TECHNICAL EVALUATION REPORT

REVIEW OF LICENSEES' RESOLUTION OF OUTSTANDING ISSUES FROM NRC EQUIPMENT ENVIRONMENTAL QUALIFICATION SAFETY EVALUATION REPORTS (F-11 and B-60)

PUBLIC SERVICE ELECTRIC AND GAS COMPANY
SALEM NUCLEAR GENERATING STATION UNIT 1

NRC DOCKET NO. 50-272

Figure A-3. Post-Accident Temperature Profile (Inboard/Outboard Penetration Area (MSLB)) [64]

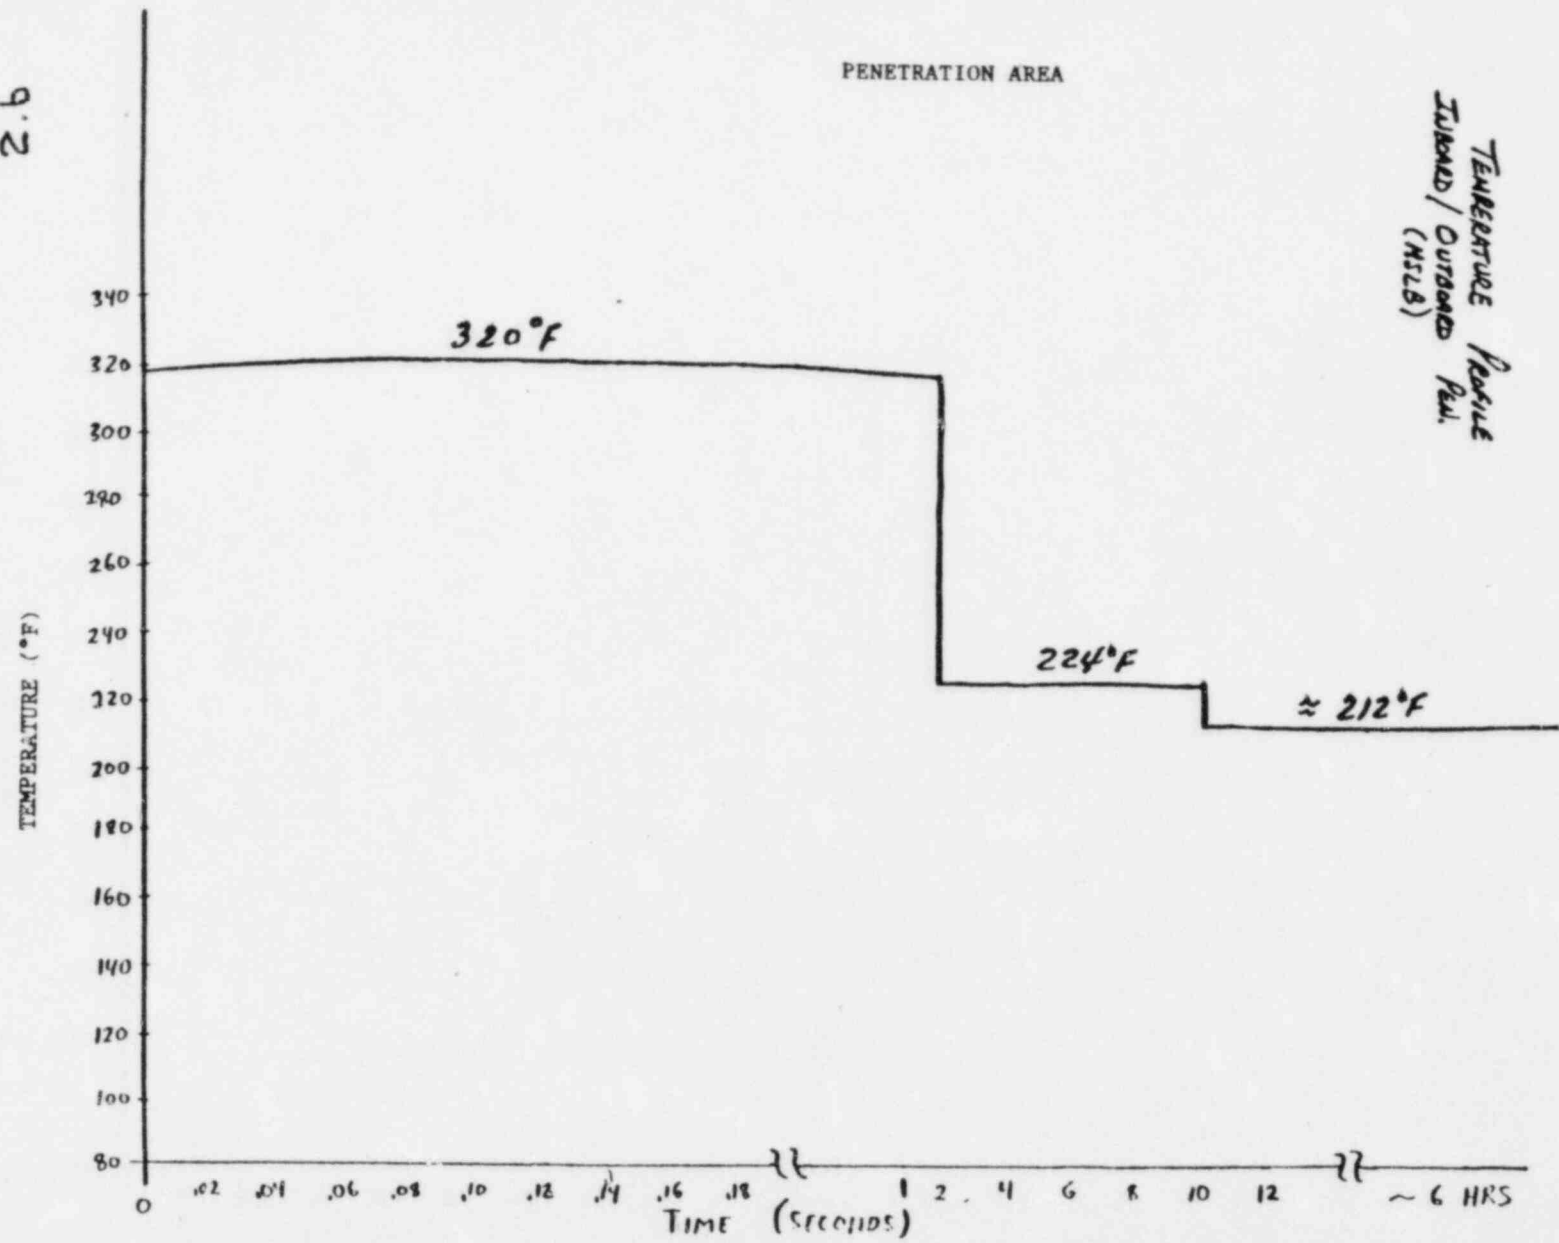
It is not clear how long the profile (temperature) extends beyond 6 hours - see appendix A figure A-3. It is our judgment that the test duration is not a problem since the ambient temperature post-accident shall not remain at 212°F for any great length of time.
